SUBJECT: WOLF CREEK GENERATING STATION - STAFF ASSESSMENT OF
INFORMATION PROVIDED PURSUANT TO TITLE 10 OF THE *CODE OF
FEDERAL REGULATIONS* PART 50, SECTION 50.54(f), SEISMIC HAZARD
REEVALUATIONS FOR RECOMMENDATION 2.1 OF THE NEAR-TERM TASK
FORCE REVIEW OF INSIGHTS FROM THE FUKUSHIMA DAI-ICHI ACCIDENT
(TAC NO. MF3755)

STAFF ASSESSMENT BY THE OFFICE OF NUCLEAR REACTOR REGULATION

RELATED TO SEISMIC HAZARD AND SCREENING REPORT

WOLF CREEK GENERATING STATION

Figure 3.3- 1Plot of Staff's and Licensee's Base Case Shear-Wave Velocity Profiles for the Wolf Creek site

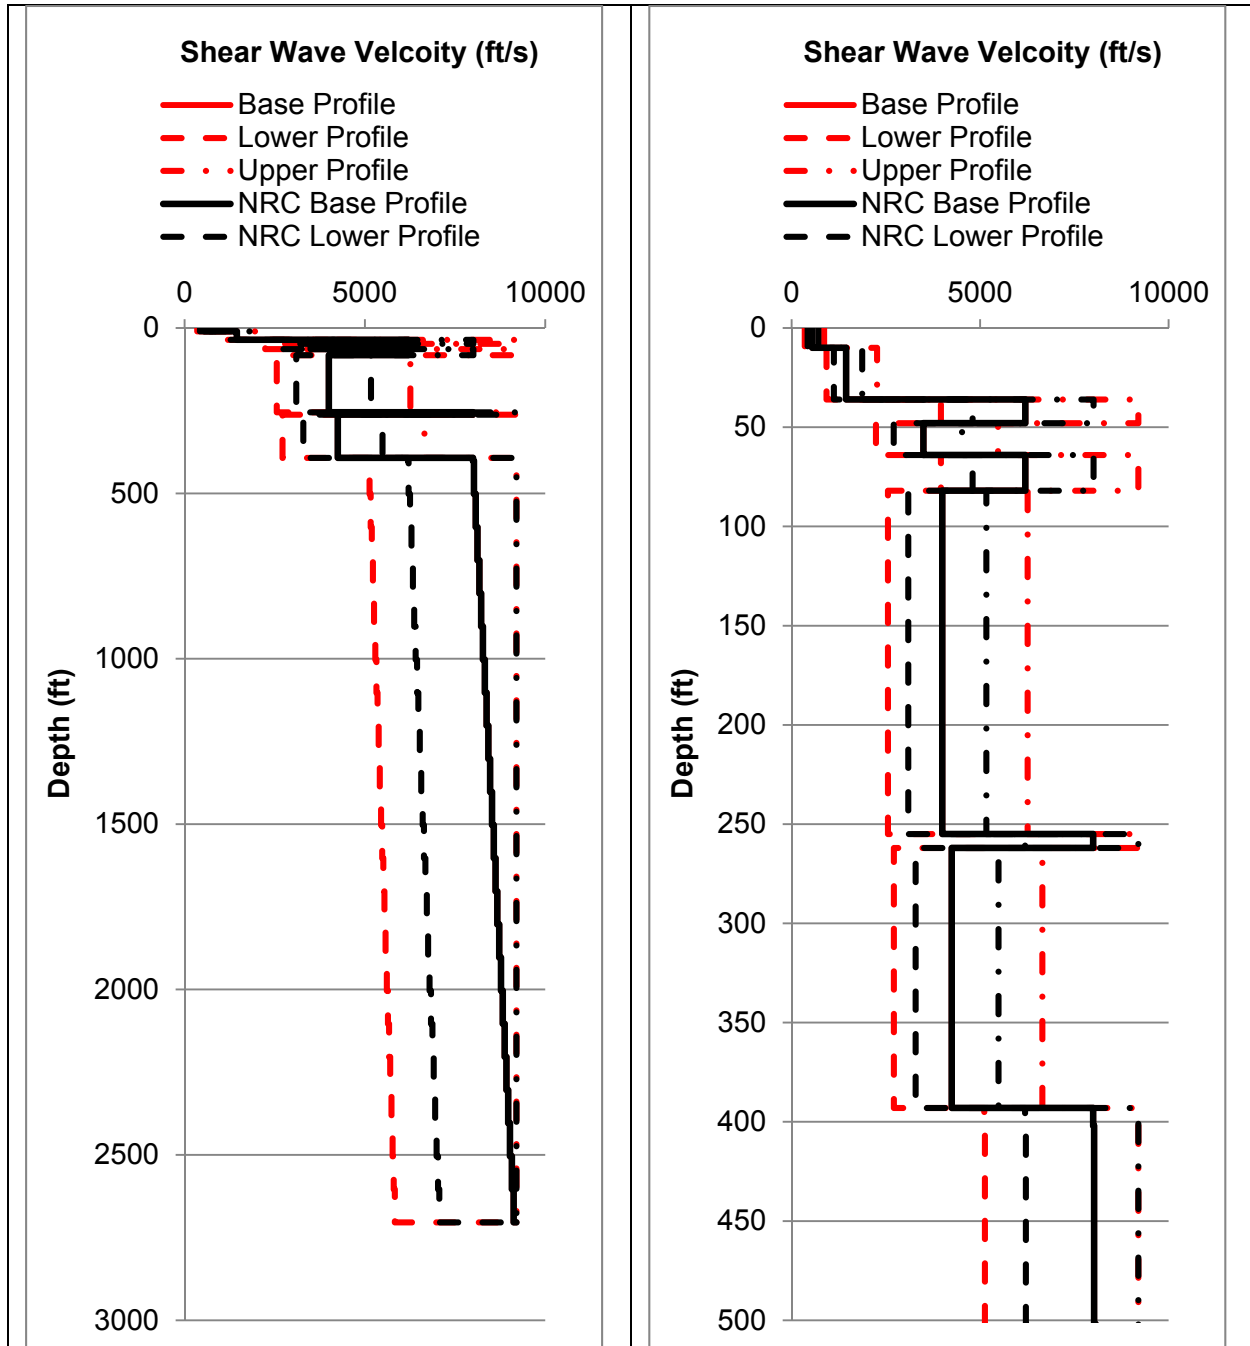
To characterize the subsurface geology, the licensee developed three site base case profiles. The middle, or best estimate, profile was developed using the specified shear wave velocities with a deepest velocity of 8,000 fps [2,438 m/s] and a gradient of 0.5 ft/s/ft, resulting in a base-case shear wave velocity of 9,075 fps [2,766 m/s] at a depth of 2,700 ft [823 m]. Upper and lower base case profiles were developed using a scale factor of 1.57 to reflect a natural log standard deviation of 0.35. Consistent with the SPID, to account for randomness in material properties across the plant site, the licensee stated that it randomized each of its three base case shear-wave velocity profiles. Figure 3.3-1 of this assessment shows the licensee's three base case shear-wave velocity profiles.

To confirm the licensee's site response analysis, the staff performed site response calculations for the Wolf Creek site. The staff independently developed three base case shear-wave velocity profiles from the information provided in USAR. The staff developed three separate profiles in order to capture the epistemic uncertainty in the modeled profiles. The USAR for Wolf Creek provides detailed information on the dynamic properties of the shallow site formations collected from numerous geophysical surveys including refraction, uphole compressional wave, uphole and crosshole shear wave, surface waves and ambient vibrations. Most of the shear wave velocities listed in the USAR were calculated from the compression wave velocities estimated from the refraction surveys. The NRC staff's base case shear-wave velocity profiles are shown along with the licensee's base case profiles in Figure 3.3-1 of this assessment. The staff's

shear wave velocity profiles are almost identical to those submitted by the licensee due to the detailed information in the USAR which is also presented in Table 2.3.2-1 of the SHSR.

Figure 3.3- 2 Plot Comparing the Staff's and the License's Median Amplification Functions and Uncertainties for two input loading levels for the Wolf Creek site

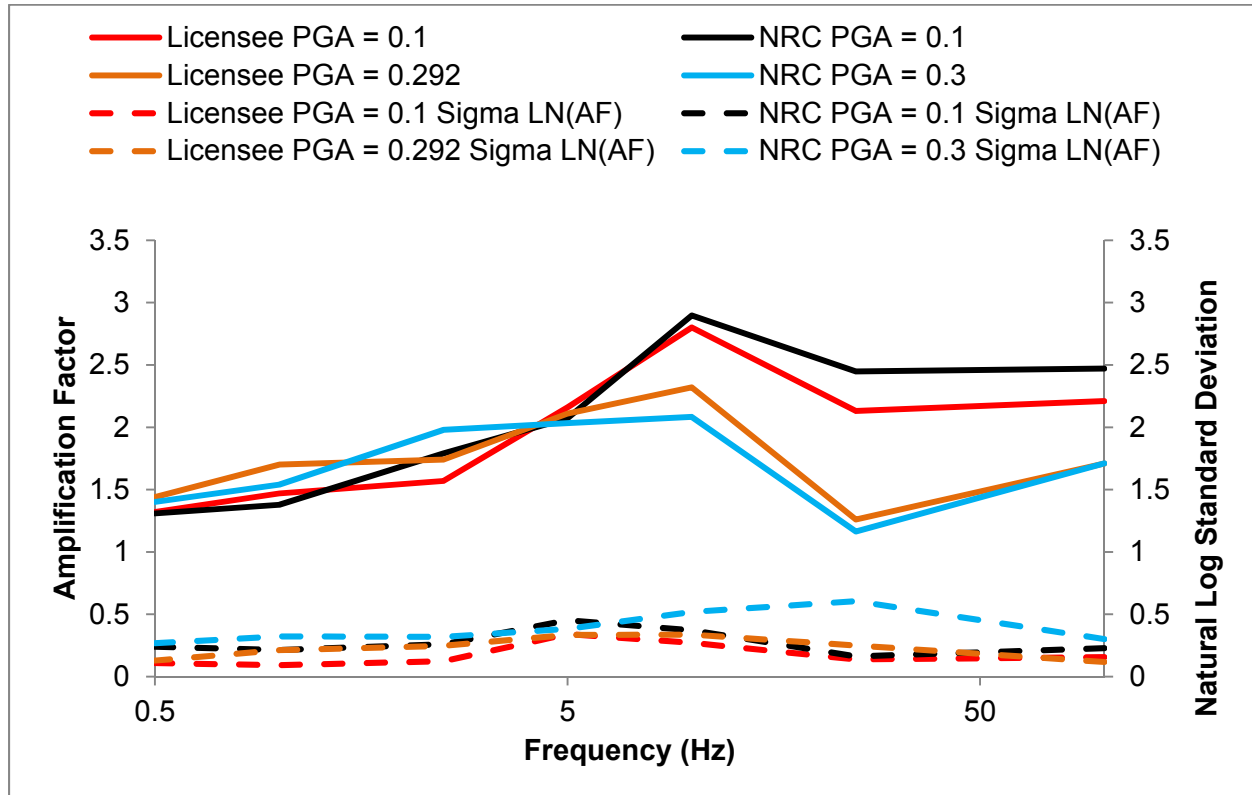
In order to calculate control point hazard curves for the Wolf Creek site, the staff developed median amplification functions for several different loading levels representing the possible hazard at the Wolf Creek site. The median site amplification and associated uncertainty for two separate loading levels are shown in Figure 3.3-2 of this assessment. A comparison of both the NRC staff's and licensee's site amplifications shows that they are similar in shape with minor differences at the higher frequency levels. These differences are due to small differences in the NRC staff's and licensee's velocity profiles in the rock layers and due to the wider range of uncertainty in kappa used by the NRC staff for its site response analysis. The licensee's and NRC staff's control point hazard curves resulting from the convolution of the site amplification with the PSHA rock hazard are shown in Figure 3.3-3 of this assessment. As shown in Figure 3.3-3, the licensee's and NRC staff's control point hazard curves are nearly identical.

Figure 3.4-1 Comparison of the Staff's GMRS with Licensee's GMRS and the SSEs for the Wolf Creek Site (Powerblock and Non-Powerblock SSE (used for Screening))

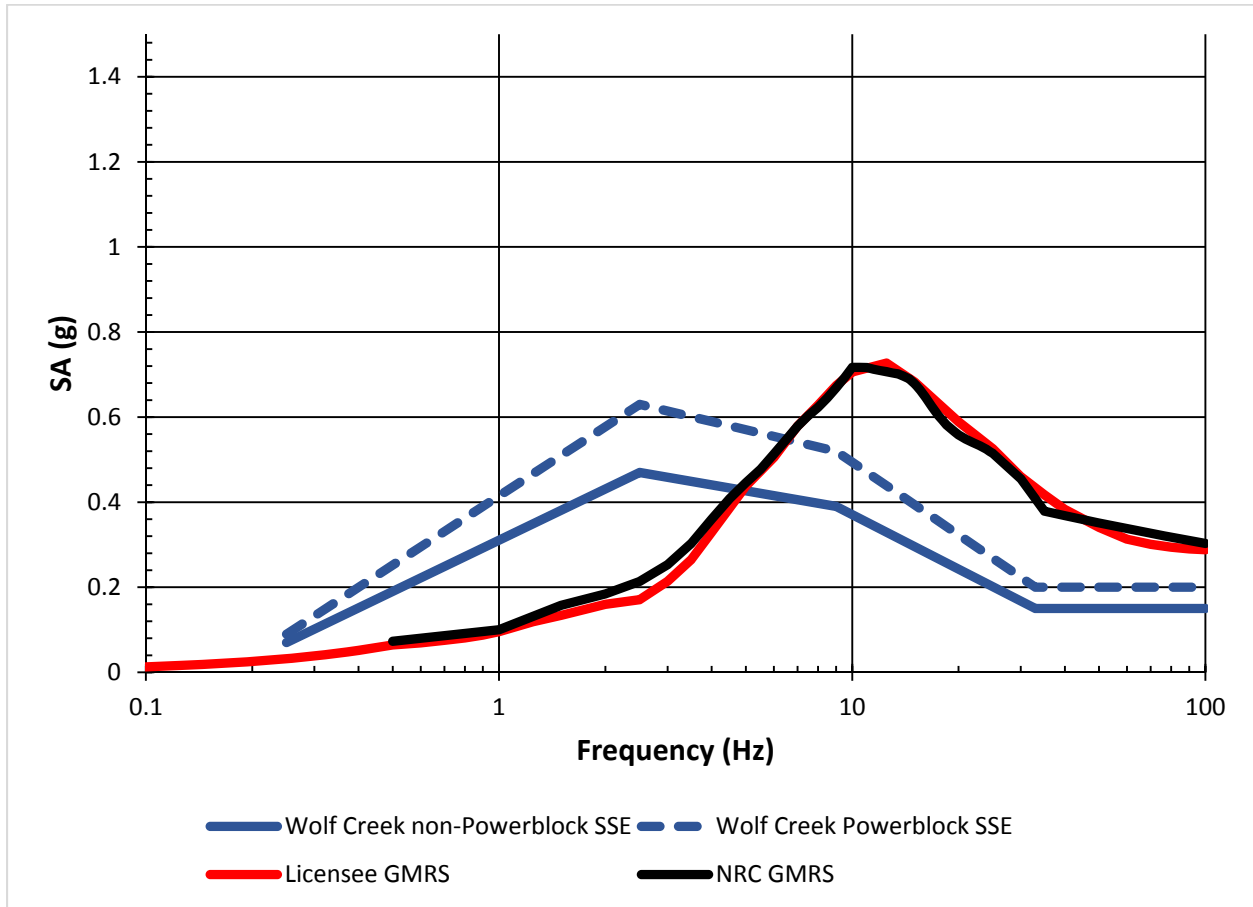
The NRC staff independently calculated the 10^{-4} and 10^{-5} UHRS using the results of its confirmatory PSHA and site response analyses, as described in Sections 3.2 and 3.3 of this staff assessment, respectively. Figure 3.4-1 of this assessment shows a comparison of the GMRS determined by the licensee to that determined by the NRC staff. As shown, the licensee's and NRC staff's GMRS are very similar.

The NRC staff confirms that the licensee used the present-day guidance and methodology outlined in RG 1.208 and the SPID to calculate the horizontal GMRS, as requested in the 50.54(f) letter. The NRC staff performed both a PSHA and site response confirmatory analysis and achieved results consistent with the licensee's horizontal GMRS. As such, the NRC staff concludes that the GMRS determined by the licensee adequately characterizes the reevaluated hazard for the Wolf Creek site. Therefore, this GMRS is suitable for use in subsequent evaluations and confirmations, as needed, for the response to the 50.54(f) letter.
